ADDENDUM NO.2	7/10/90
KENTON PETERS + ASSOC. 44 E. MIFFLIN MADISON, WISCONSIN 53703 (608) 255-5656	JEFFERSON COUNTY LAW ENFORCEMENT CENTER JEFFERSON, WISCONSIN
	EA-15

GROUND FLOOR PLAN — 6-11-90
1/8"=1'-0"
POWER, TV & COMMUNICATION — E-5

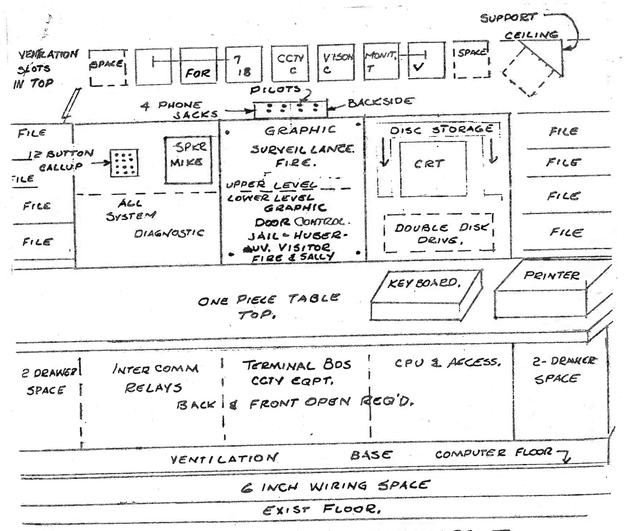
1. J033 - Mount receptacles 2" to center above backsplash.
2. Install GFI receptacle in chase adjacent to Rooms J078 and J081.
3. J076 - Relocate receptacle on East wall 4' 0" to the North. Relocate receptacle on South wall to East wall 4' 0" off South wall.

4. J071 - Install 1 'GFI' receptacle on South wall 8' 0" off East wall. Install 2 'GFI' receptacles on North wall - 1-7' 0" off East wall, 1-4' 0" off West wall. Receptacles to be controlled from control Room J023. Mount receptacles at 24" AFF.

5. J026 - Install 1 'GFI' receptacle on East wall 13' 0" off North wall. Install 1 'GFI' receptacle on North wall 14' 0" off West wall. Install 1 'GFI' receptacle on West wall 8' 0" off South wall. Receptacles to be controlled from control Room J023. Mount receptacles at 24" AFF.

6. Provide junction box and 3/4" conduit to an accessible space above ceiling in Rooms J025 and J026 in Southeast corner adjacent to overhead door in Room J095.

7. Add connections for incinerator in Room S1007. Provide receptacle for heat tape connection to Room S1015.
